# Conceptual Review Agenda

Schedule for 10/19/15 to 10/19/15

**CALVARY BAPTIST TEMPLE**  
 PARKING LOT PAVEMENT PROJECT

**Re:** 2420 Laporte Ave - Plat

SHEET TITLE:  
**PARKING LOT PAVEMENT**

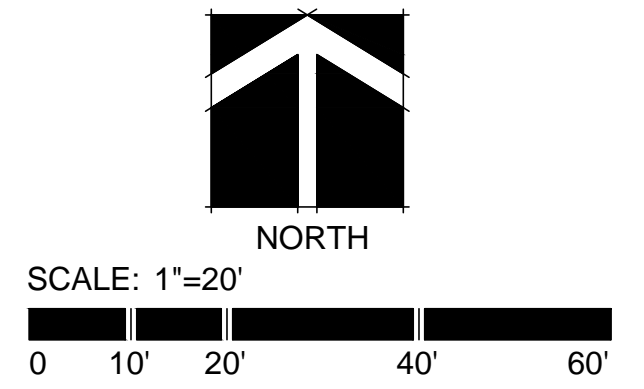
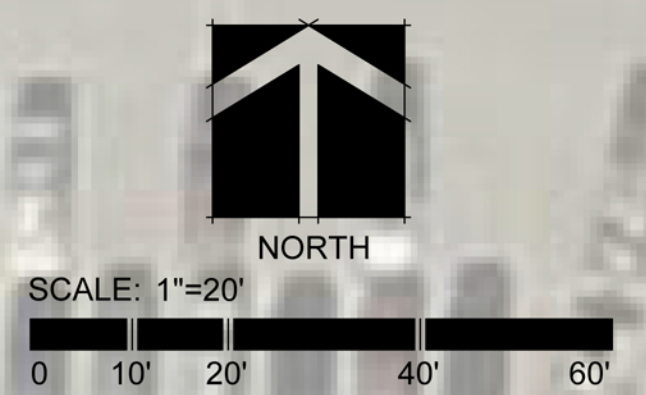
1. While there are a sufficient number of HC parking stalls the most eastern stall doesn't comply as there is no hatched out area adjacent to the stall for access onto. A ramp for it may also be a question.
2. The property isn't platted. If this conceptual review leads to formal development review process then platting of the property will be required.
3. The some parking area islands don't appear to be landscaped.
4. A formal landscape plan is required listing species, sizes, etc.
5. The submittal will at least need notes on the site plan concerning the lighting.
6. A sidewalk from the main entrance to the building to the public sidewalk will need to be included.
7. Bike racks will need to be installed at the ratio of 1 per 3000 sf of building with a minimum of 4 spaces.

10. LCUASS parking setbacks (Figure 19-6) apply and will need to be followed. As the parking is laid out on the plan that was submitted this is being met.

CONCEPT PLAN  
810 N. COLLEGE AVE.  
FORT COLLINS

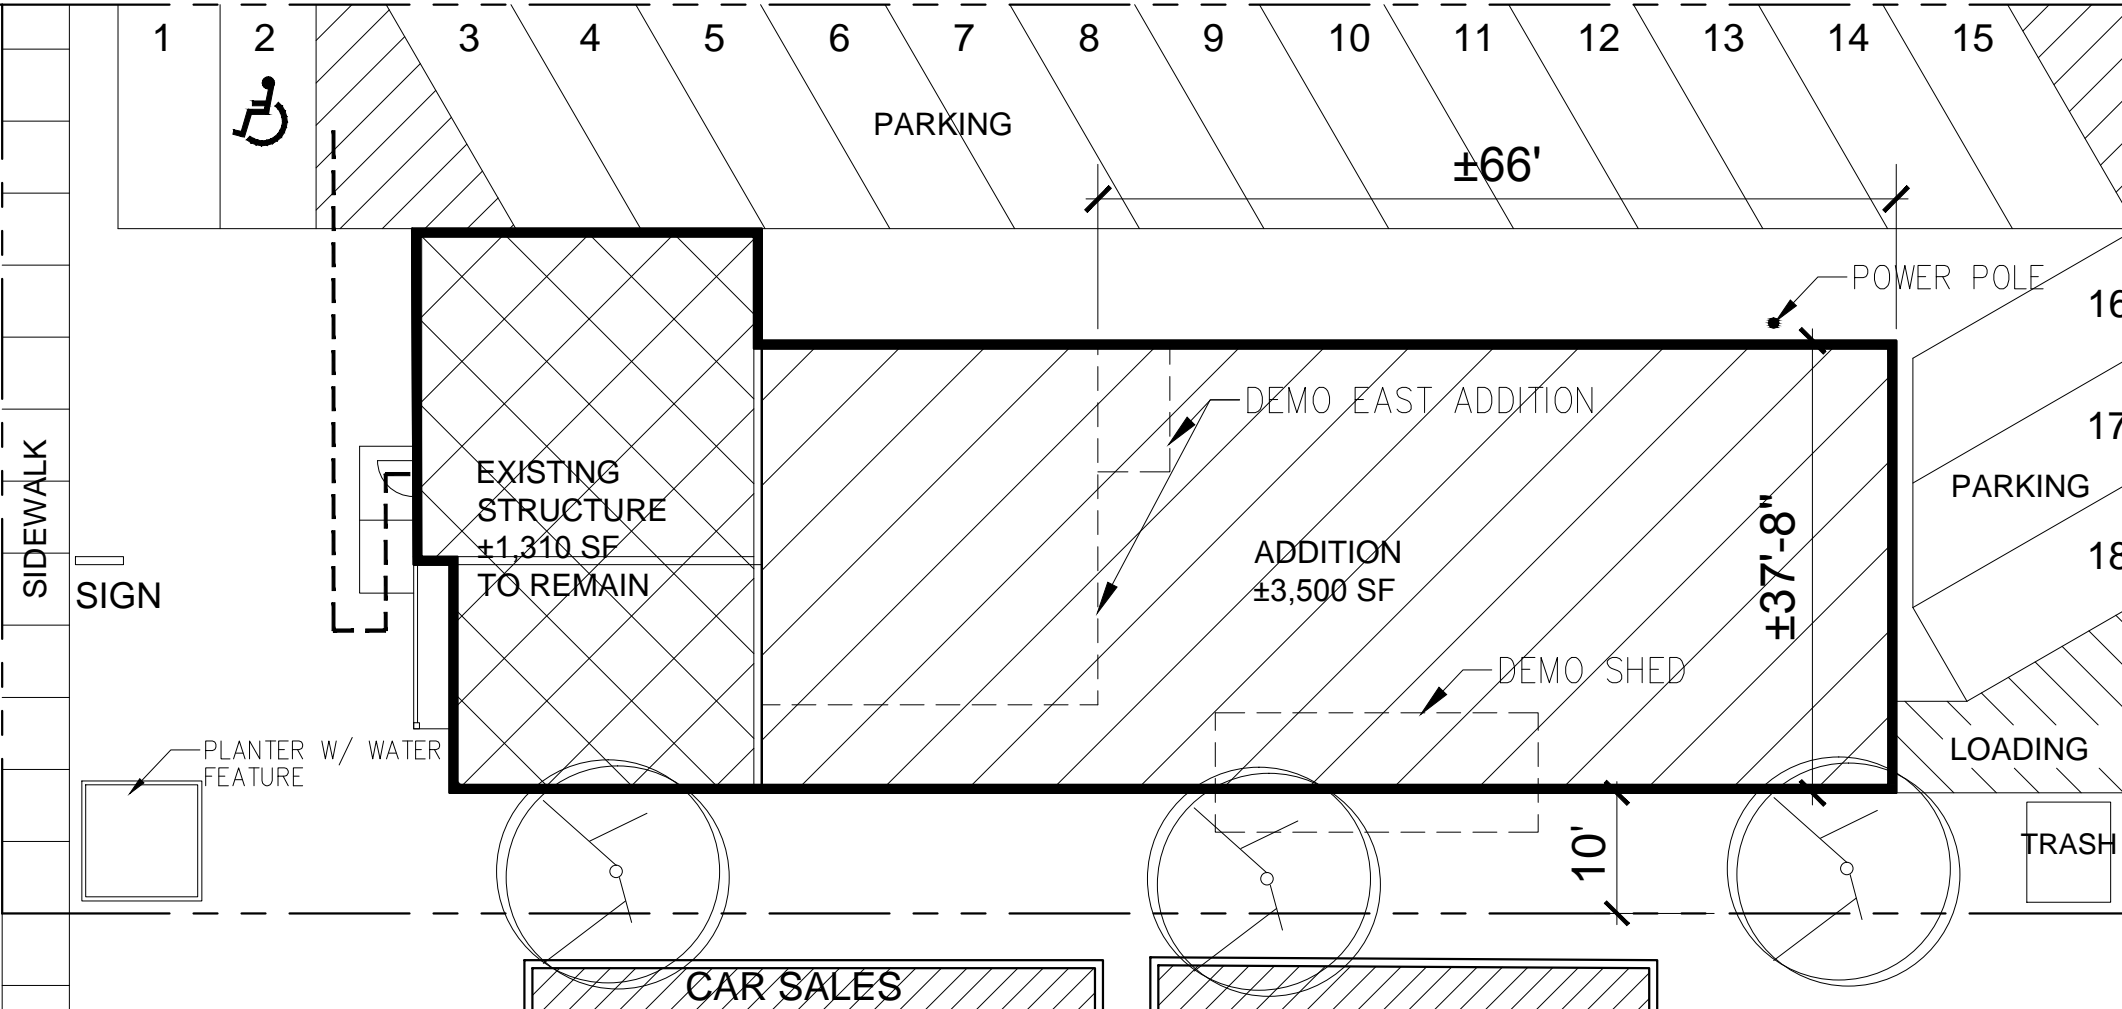
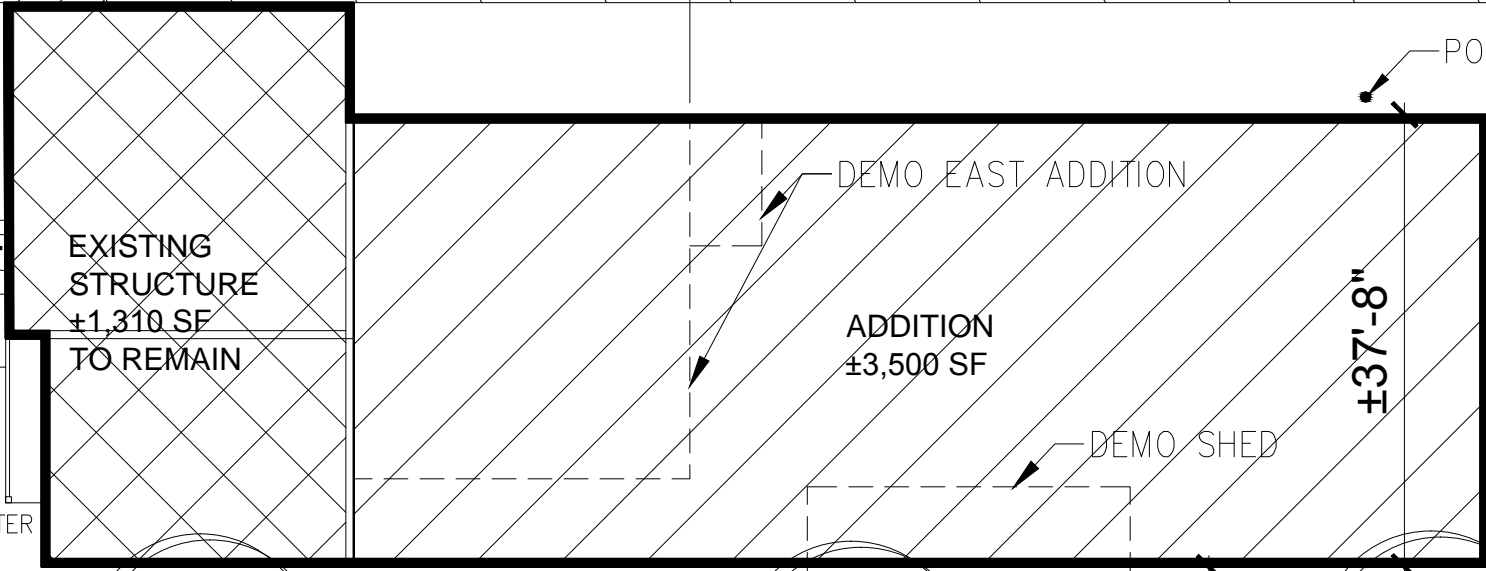
2. A landscaping plan is required. A couple of landscaping island should be considered to break up what is already a sea of asphalt. If parking in front of the building is eliminated the code requires that much of the asphalt be removed and replaced with grass/landscaping.

11. An excavation permit will need to be obtained prior to starting any work on the site.
12. LCUASS parking setbacks (Figure 19-6) apply and will need to be followed depending on parking design. This will likely impact a few of the spaces closest to College Ave.
